service bulletin

No. 90-8

Obstructed Fuel Line Connector – Mariner/Mercury 8-200 Models

Figure 1. Fuel Line Connector P/N 22-13563A3

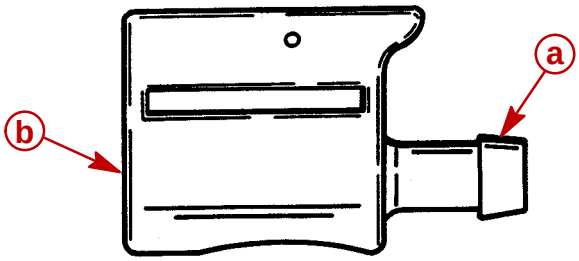
Fuel line connector P/N 22-13563A3 may have excess plastic in the fuel passageway inside the housing. Excess plastic may prevent full coupling of the fuel line to the outboard furl connector and/or restrict fuel flow to the engine. Outboards and service stock listed require inspection of fuel line connector.

Figure 3. Obstructed Fuel Connector

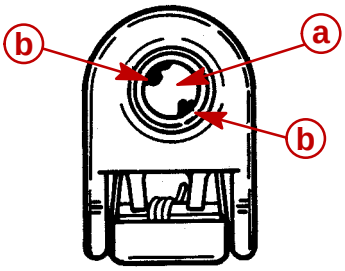
Inspect for excess plastic in passageway by looking into connector from fuel line barbed end. Brass piece on opposite end of connector should be fully visible. If brass piece is not visible, the connector is defective and must be replaced.

a - Brass Piece Partially Visible
b - Excess Plastic in Passageway
